DART AEROSPACE LTD		Work Order:	87322
Description: Crosstube High Fwd (205/212/412)		Part Number:	D212-664-101
Inspection Dwg: D212-664-141 Rev: D		Page 1 of 1

DRAWING NO. D212-664-141	TITLE XTUBE ASSY (205/212/412 HI FWD)	REV. D	DART AEROSPACE LTD ENGINEERING ORDER		D.E.O. NO. D212-664-141-D-1	SHEET NO. SHEET 1 OF 2	SCALE NTS
DRAWN	CHECKED	MFG. APPR.	APPROVED	DE APPR.			
DATE 11.04.07	DATE 11.04.11	DATE 11.04.12	DATE 11/04/12	DATE 11.04.12

DRAWING NO. D212-664-141	TITLE CROSSTUBE ASS'Y (205 HI FWD)	REV. D	DART AEROSPACE LTD ENGINEERING ORDER		D.E.O. NO. D212-664-141-D-2	SHEET NO. SHEET 1 OF 1	SCALE NTS
DRAWN <i>UP</i>	CHECKED <i>AS</i>	MFG. APPR. <i>AS</i>	APPROVED <i>MD</i>		DE APPR. <i>MD</i>		
DATE 11.07.15	DATE 11.07.20	DATE 11.07.21	DATE 11/07/21		DATE 11.07.21

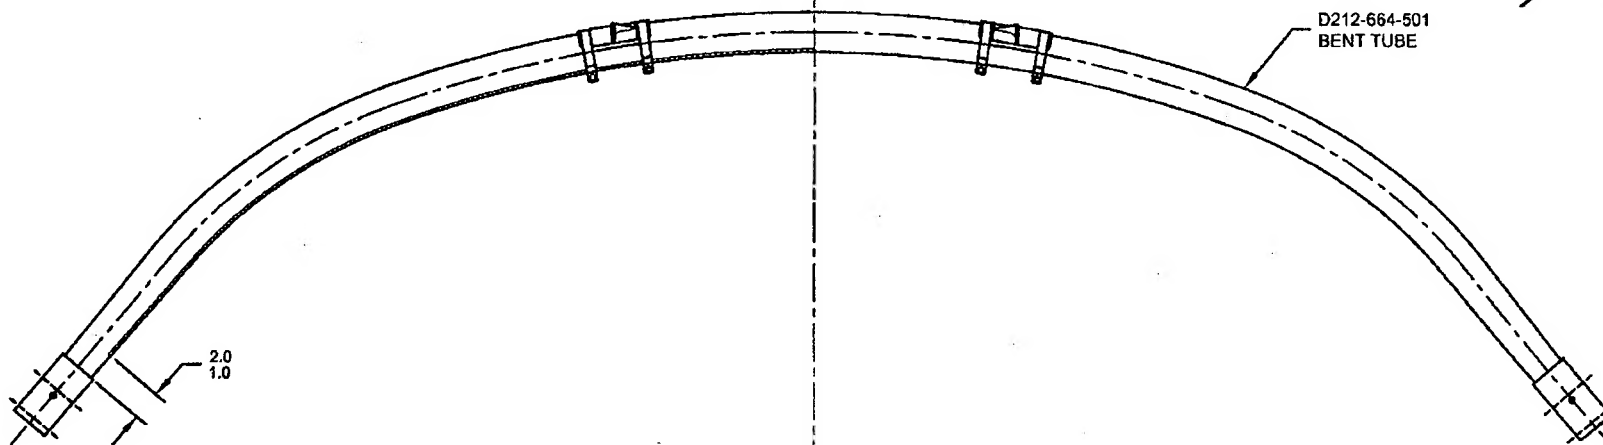
ADD AN INSPECTION WINDOW TO UNDERSIDE OF CROSSTUBE.

NOTES 2 OF SHEET 1 IS AMENDED AS FOLLOWS:

- 2) FINISH: CHEMICAL CONVERSION COAT PER DART QSI 005 4.1
PRIME INSIDE AND OUTSIDE PER DART QSI 005 4.2
MASK UNDERSIDE OF CROSSTUBE AS SHOWN (HATCHED AREA) AND
PAINT OUTSIDE PER DART QSI 005 4.2
REMOVE MASKING AND APPLY CLEAR COAT

- 2) FINISH: CHEMICAL CONVERSION COAT PER DART QSI 005 4.1
PRIME INSIDE AND OUTSIDE PER DART QSI 005 4.2
PAINT OUTSIDE PER DART QSI 005 4.2

MASK AREA PRIOR TO PAINTING,
REMOVE MASKING AFTER PAINT
AND APPLY CLEAR COAT
